**City of Bellevue
Development Services Department
Land Use Staff Report**

Proposal Name: Berdan Garage Addition

Proposal Description: Land Use review of a Critical Area Land Use Permit proposing a modification of the structure setback from the stream buffer of Vasa Creek in order to construct a garage addition to the existing home and restore an area of the stream buffer with native plants.

File Number: 09-114003-LO

Figure 1

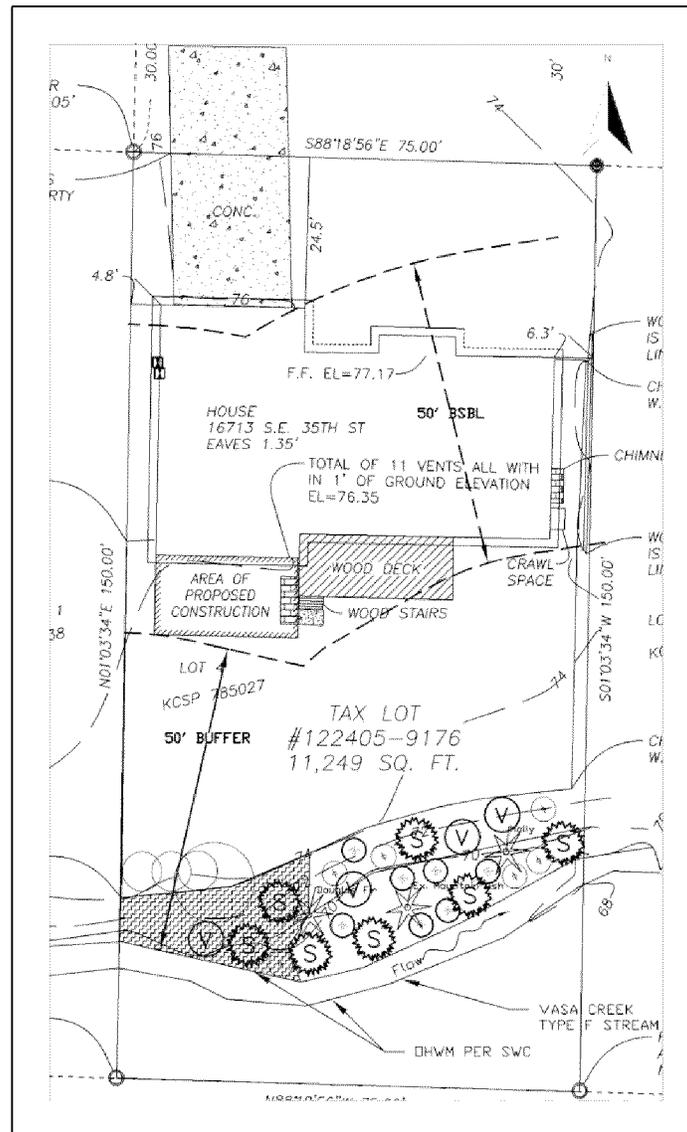
The applicant proposes to construct an addition that will enlarge an existing garage attached to a single-family residence. The proposed garage addition will extend into the structure setback from the stream buffer of Vasa Creek which is located along the south of the subject site. This Critical Area Land Use Permit application proposes to modify the stream structure setback to allow the garage addition. As mitigation, planting is proposed along the stream bank of Vasa Creek. In addition to the garage addition, repair of the existing garage will occur to address damage sustained from a tree impact. See Figure 1 below for a site plan.

This analysis indicates that the area proposed for development is currently landscaped lawn and ornamental planting immediately adjacent to the existing residence. The existing residence is already located within the 50-foot structure setback from the stream buffer. The proposed addition to the garage will fully reduce the structure setback in the

location of the proposed addition but will not modify the 50-foot stream buffer. The proposal will not disturb vegetation that is valuable as habitat and is affecting already developed portions of the site. As critical area reports are required to demonstrate an increase in the critical area functions and values resulting from the proposed development. An enhancement planting plan of the stream buffer is proposed as mitigation in order to provide an increase in critical area functions and values on the site. See Conditions of Approval in Section IX of this report.

- 1. Disturbance Limit:** The structure setback modification approved is limited to the new approximately 300 square foot garage addition depicted on the approved site plan. Any future development proposals in the structure setback area or stream buffer may require a Critical Area Land Use Permit approval.

**BERDAN PROPERTY
STREAM BUFFER
ENHANCEMENT PLANTING PLAN**

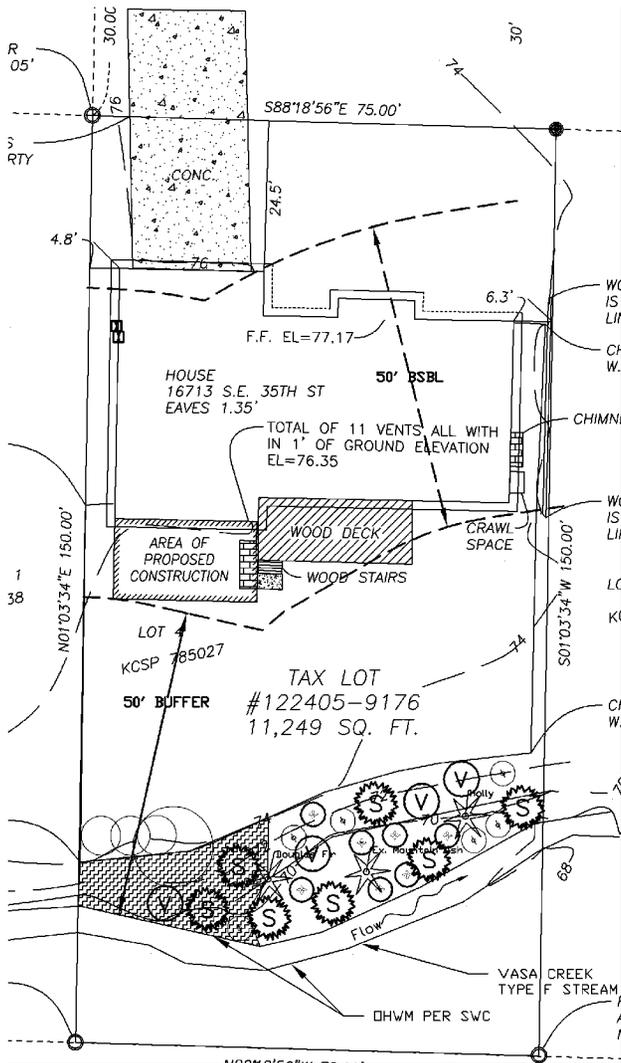
The notice of application for this project stated in the project description that the 50-foot stream buffer was also proposed to be slightly modified. Staff asked the applicant for further clarification on the plans to determine if the stream buffer would be modified as part of the proposal. In addition staff recommended that the proposed planting area be placed along the stream bank to replace the invasive species and to locate the mitigation planting below the existing fence on the site to limit disturbance to the new plants. Staff also required the planting area to meet requirements for plant spacing and density found in the City's Critical Areas Handbook. The applicant revised the plans to confirm that the proposed modification was for the stream structure setback only and revised the planting area to be along the stream bank and to have plant spacing and density consistent with the Critical Areas Handbook.

- 5. Mitigation, Maintenance, and Monitoring:** The proposed mitigation planting is approved. Maintenance and monitoring of the planting shall be carried out as detailed in the Mitigation Plan dated April 13, 2009 prepared by Sewall Wetland Consulting, Inc. If mitigation planting is demonstrated to be healthy and established after three years of monitoring the monitoring may be discontinued, subject to inspection of the planting by Land Use staff.
